NEW FIRE STATION: ENGINE CO. 268 / LADDER CO. 137

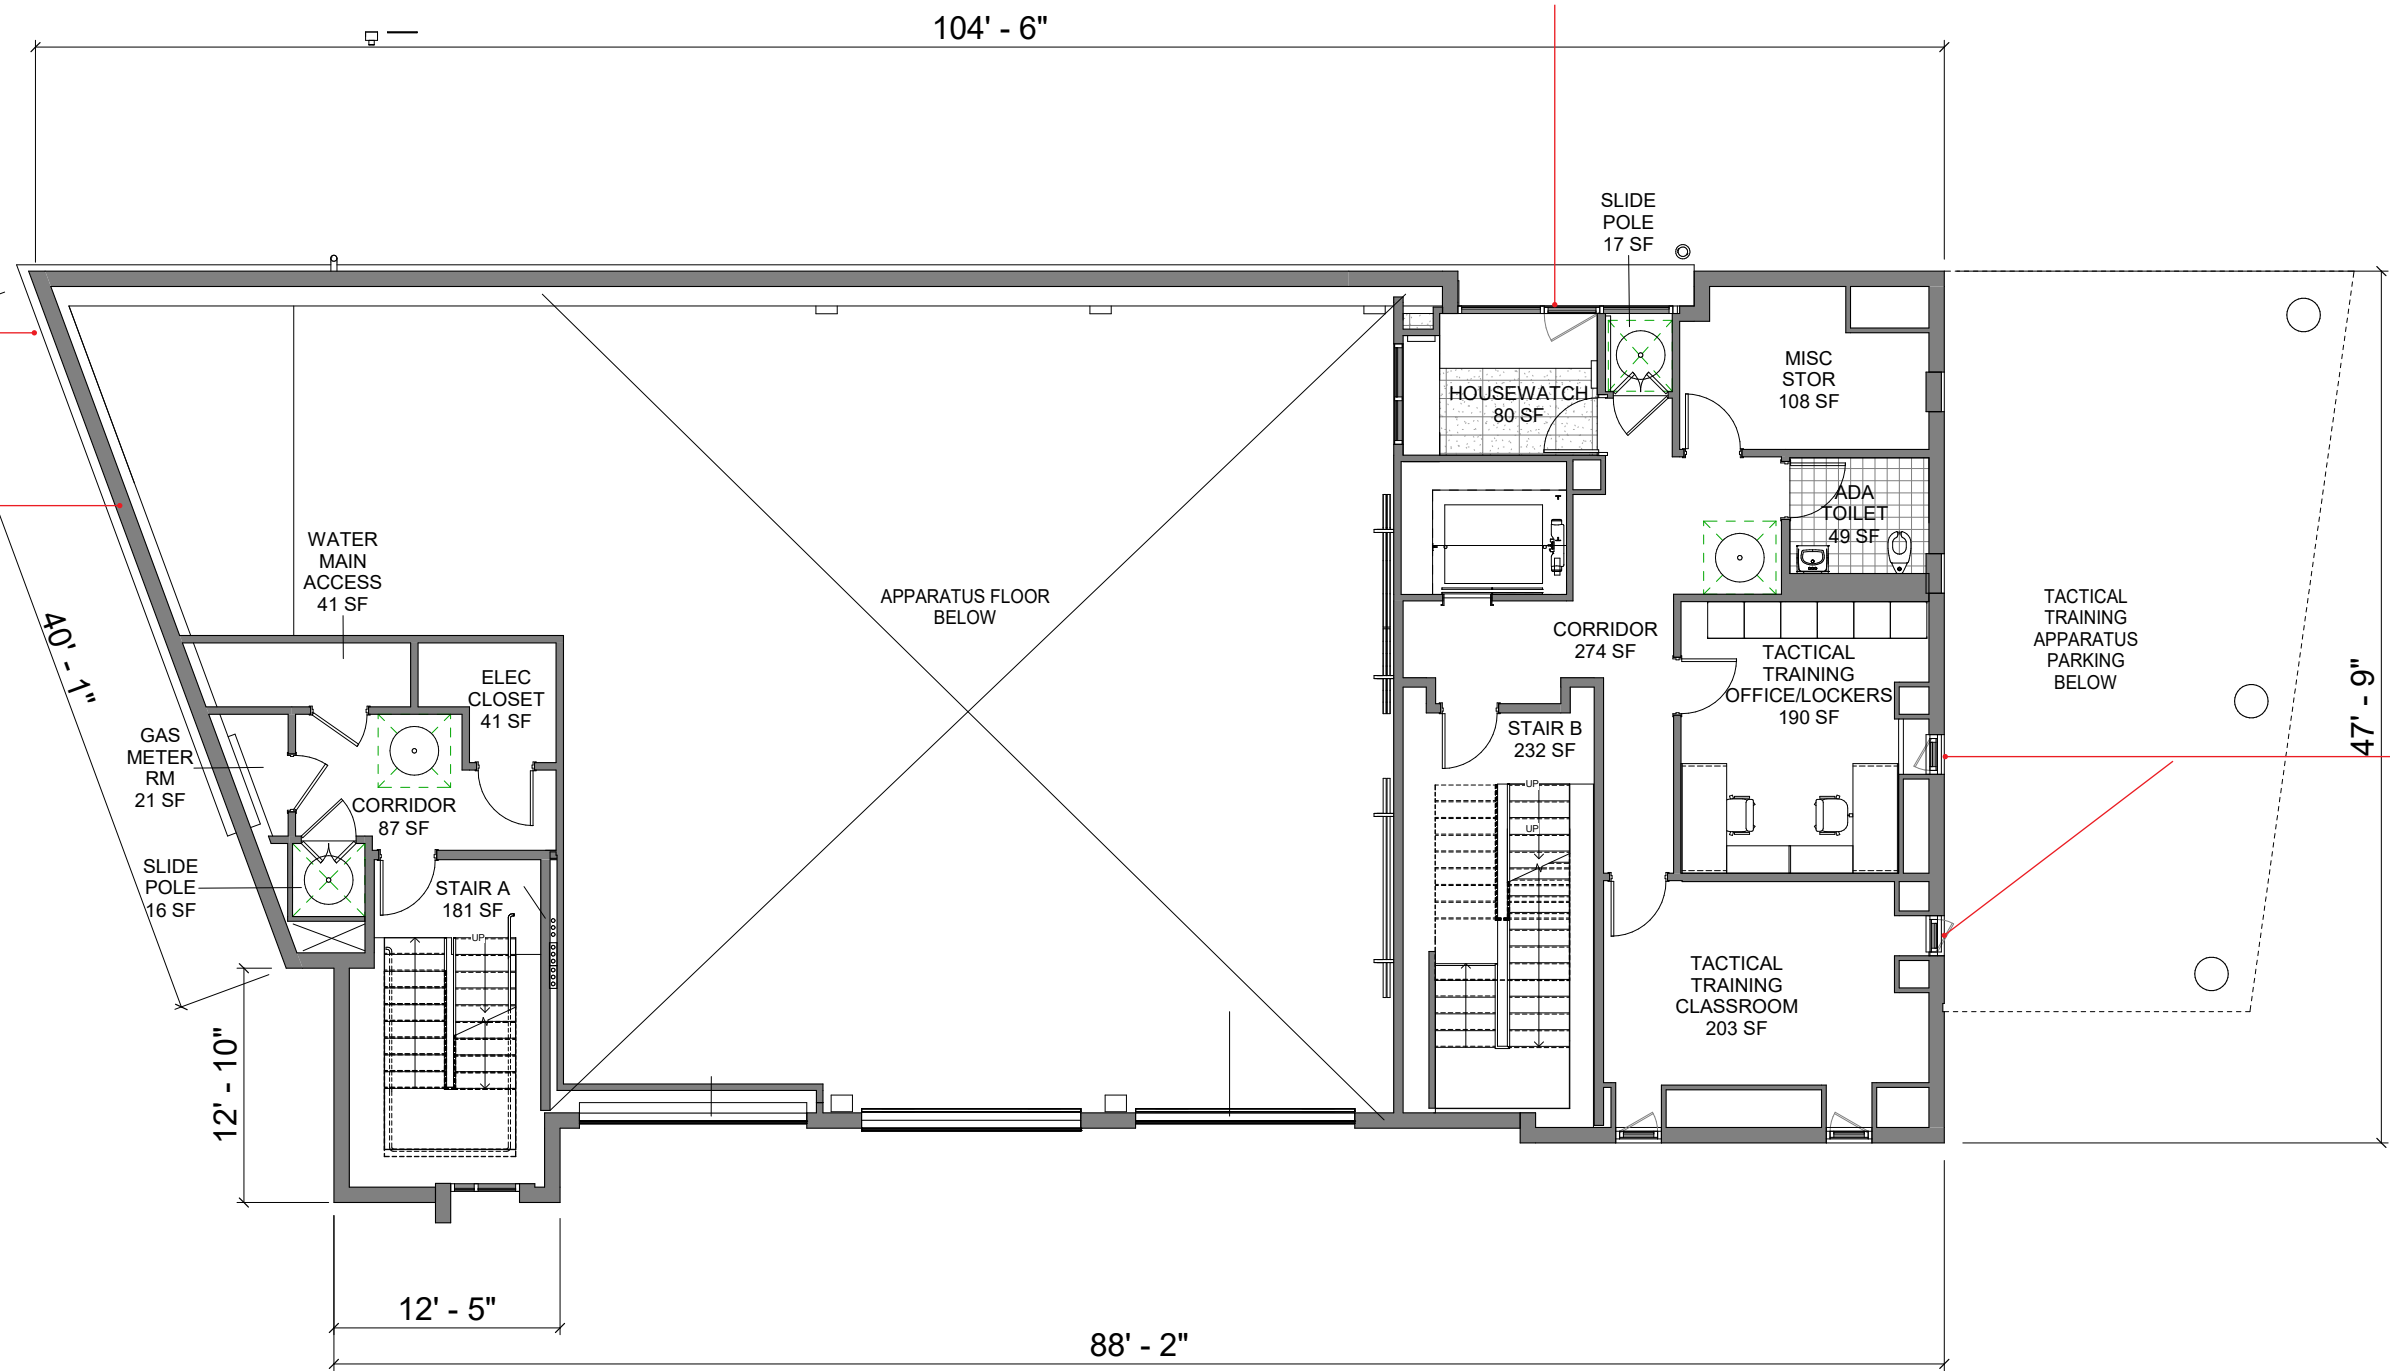
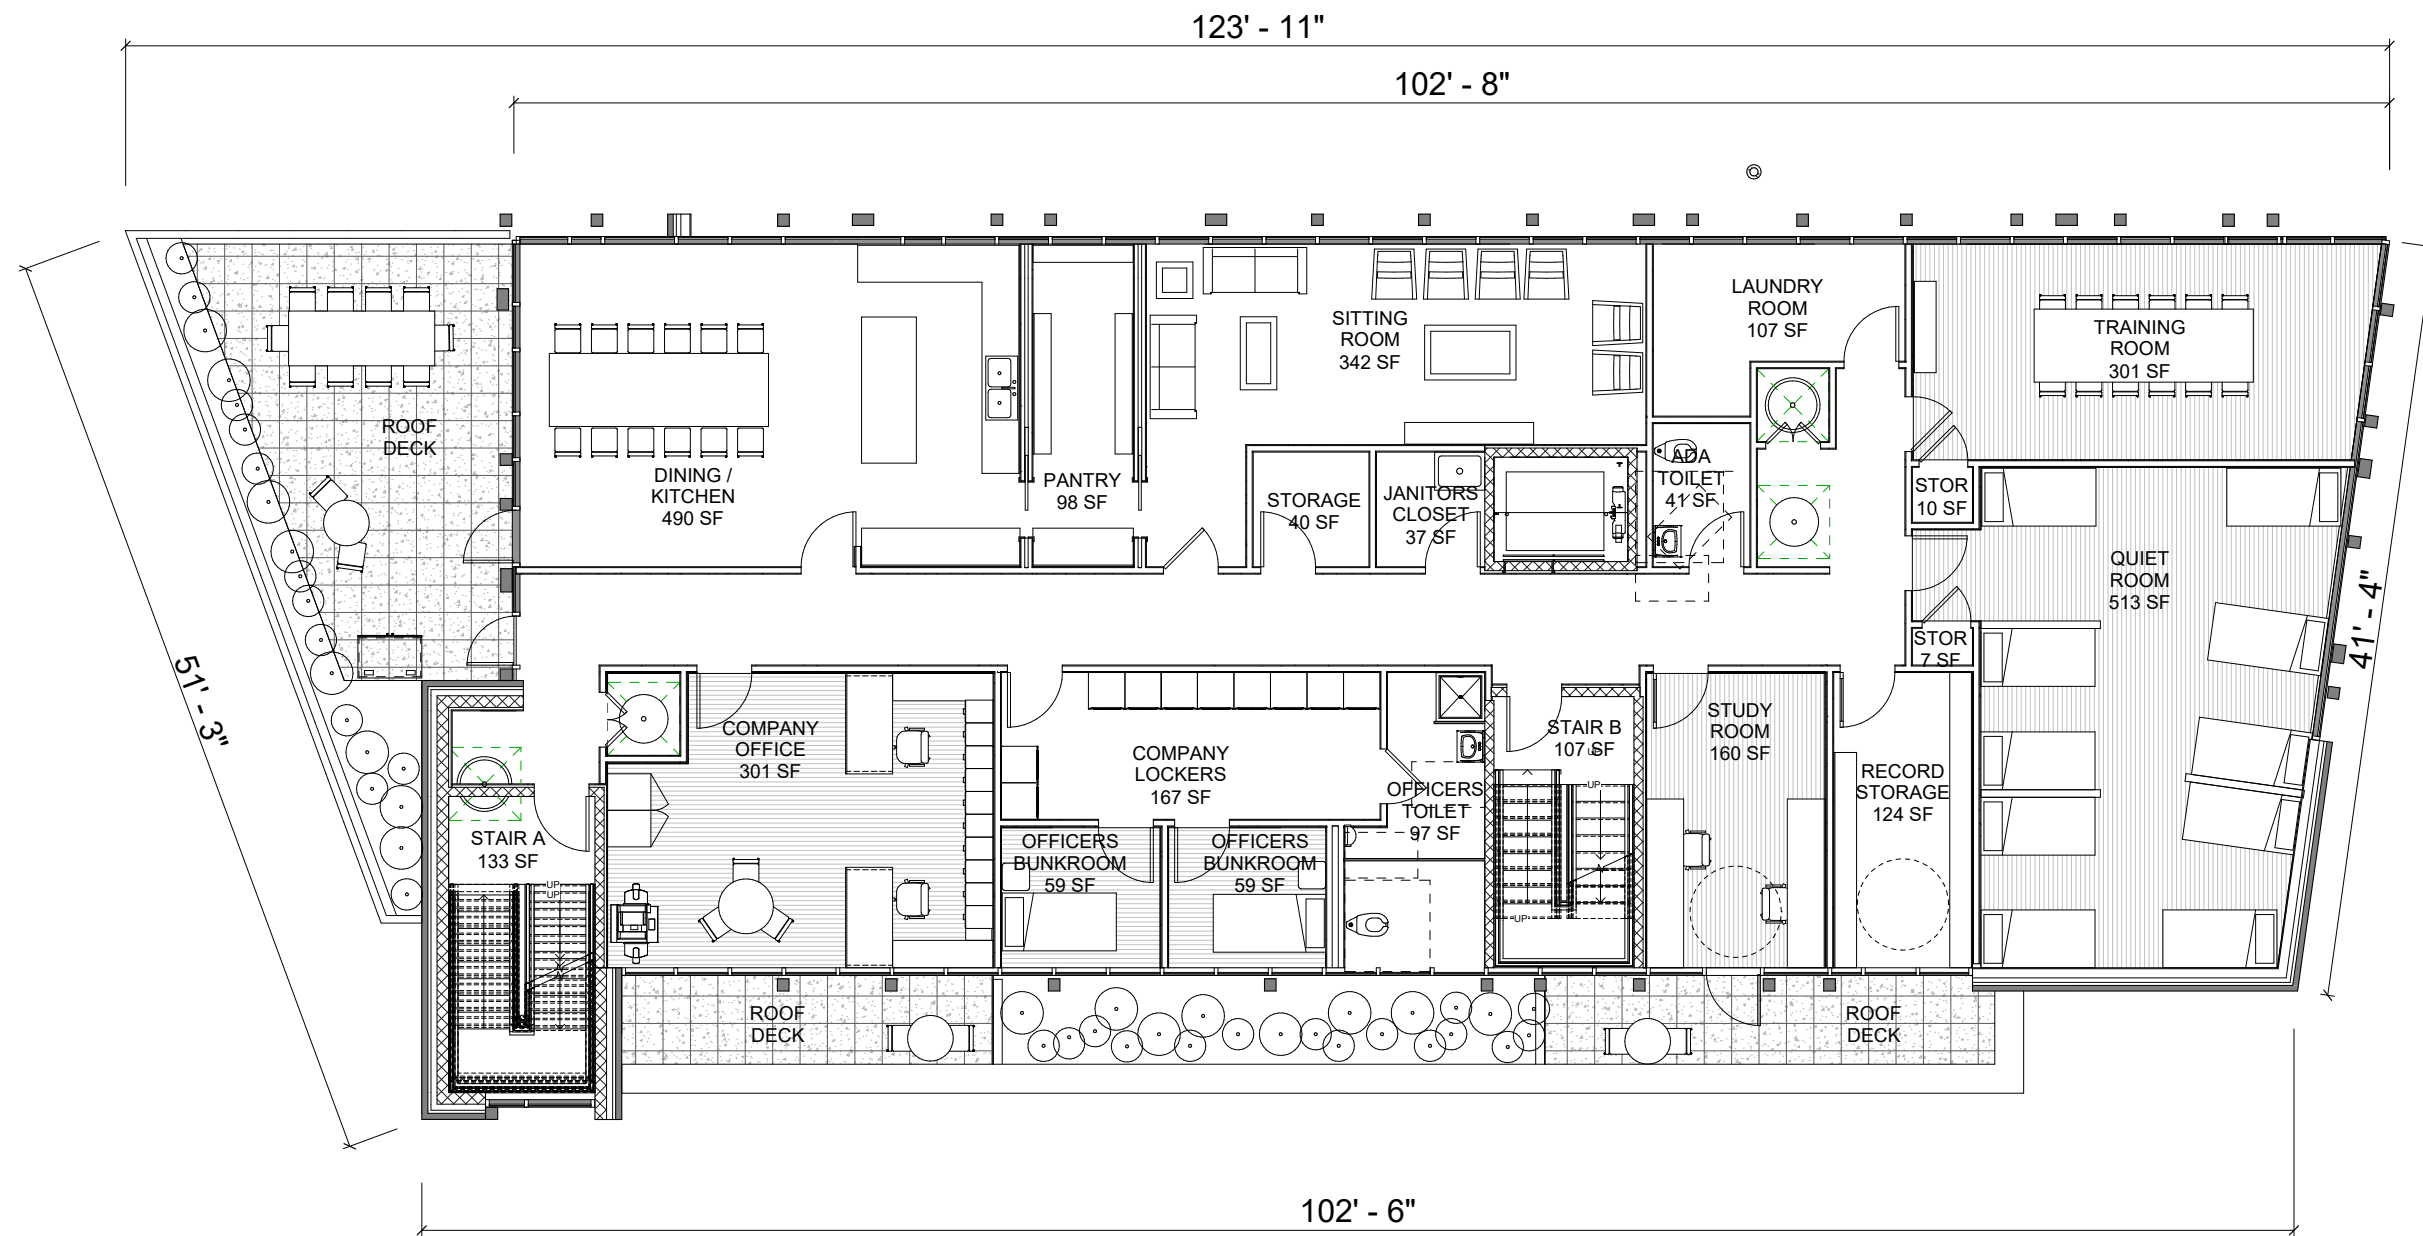
R7 - EGRESS DOOR
REMOVED DUE TO
STAIR REMOVAL

R8 - LOUVERS
REMOVED AND
REPLACED WITH
SOLID BRICK WALL

R10 - WINDOWS ADDED TO
HOUSEWATCH & SLIDE POLE
ABOVE ENTRANCE
